**RE: 2900 A&B Corona NW
Grading and Drainage Plan
Engineer's Stamp Date – 6-6-2016
Hydrology File: H11D070**

Based upon the information provided in your submittal received 6-6-2016, the above referenced Grading and Drainage Plan is approved for Building Permit with the following condition:

ENGINEER'S SEAL	2900 A&B	DRAWN BY WCV/J
		CORONA DRIVE	DATE 6-05-16
		GRADING AND DRAINAGE PLAN	21625-LAYOUT-6-05-16
	6/6/16	 <i>Rio Grande</i> <i>Engineering</i> 1606 CENTRAL AVENUE SE SUITE 201 ALBUQUERQUE, NM 87106 (505) 872-0999	SHEET # —
DAVID SOULE P.E. #14522			JOB # 21625

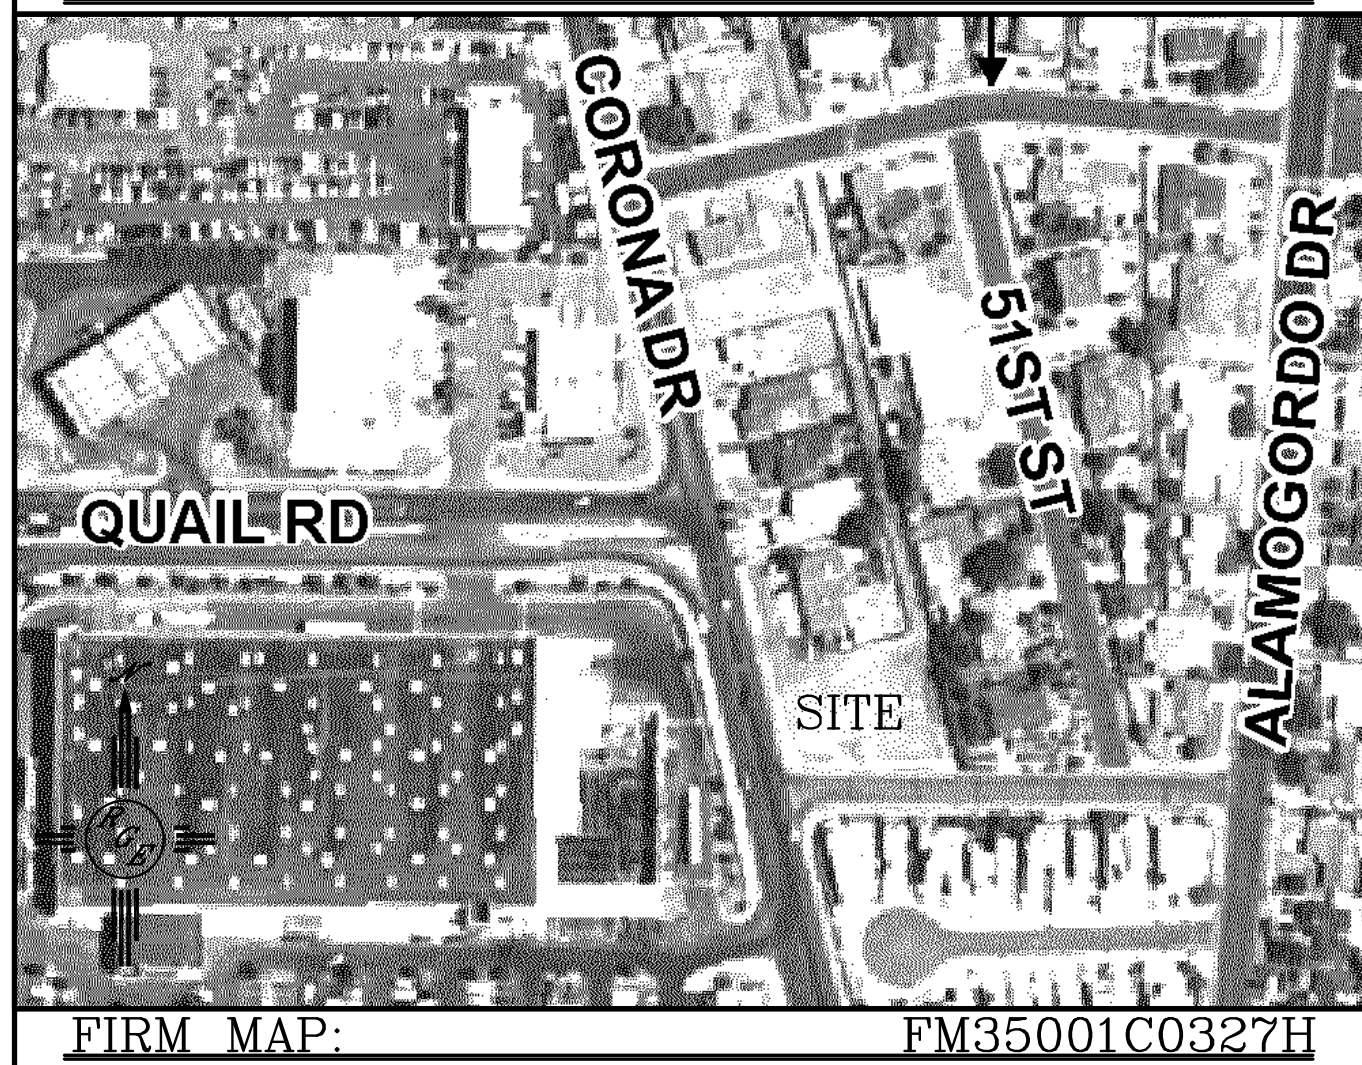
- The location of roof drains is not shown, but it appears that they will be directed North and South. Ensure that roof flows are routed through the first flush ponds.
